## Access Compliance Report Public Rights-of-Way (Curb Ramps)

Intersection ID: 28211Main Street: AUTUMN\_APPLAUSE\_DRCross Street: STAGS\_LEAP\_CTLocation:SWADA ID: C1FF8C92FCC4Ramp Type: BlendTrans2Initial Pass/Fail: FailOverall Compliance: NoSeverity Score:30

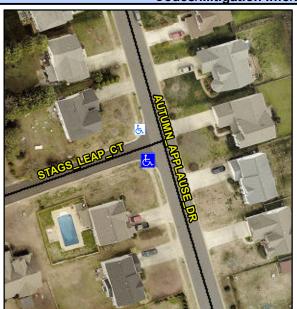
Compliance Description		Data	Compliance Description		Data
	N/A	Ramp Length (in)	95.0	Yes	BlendTrans Slope (%)	2.9
	No	Ramp Width (in)	34.0	No	BlendTrans XSlope (%)	6.0
	N/A	Flare Type LT	N/A	N/A	Flare Type RT	N/A
	N/A	Flare Slope LT (%)	N/A	N/A	Flare Slope RT (%)	N/A
	N/A	Flare Traversable LT?	N/A	N/A	Flare Traversable RT?	N/A
	N/A	Landing Length (in)	N/A	N/A	DWS Provided?	N/A
	N/A	Landing Width (in)	N/A	N/A	DWS Contrast?	N/A
	N/A	Landing Slope (%)	N/A	N/A	DWS Length (in)	N/A
	N/A	Landing X Slope (%)	N/A	N/A	DWS Full Width?	N/A
	N/A	Landing Curb? (Y/N)	N/A	N/A	DWS Offset (in)	N/A
	N/A	Shared Landing?	N/A			
	N/A	Gutter Ponding?	N/A	N/A	Gutter Slope (%)	N/A
	N/A	Gutter Lip Ht (in)	N/A	N/A	Gutter X Slope (%)	N/A
	N/A	Painted X Walk1?	No	N/A	Painted X Walk2?	No
		X Walk 1 Direction	To SE		X Walk 2 Direction	To NE
		X Walk 1 Width (in)	N/A		X Walk 2 Width (in)	N/A
		X Walk 1 Slope (%)	3.5		X Walk 2 Slope (%)	3.3

Remove & Replace Curb Ramp With Two New Directional Ramps or Equivalent.

R304.5.1, R304.5.3
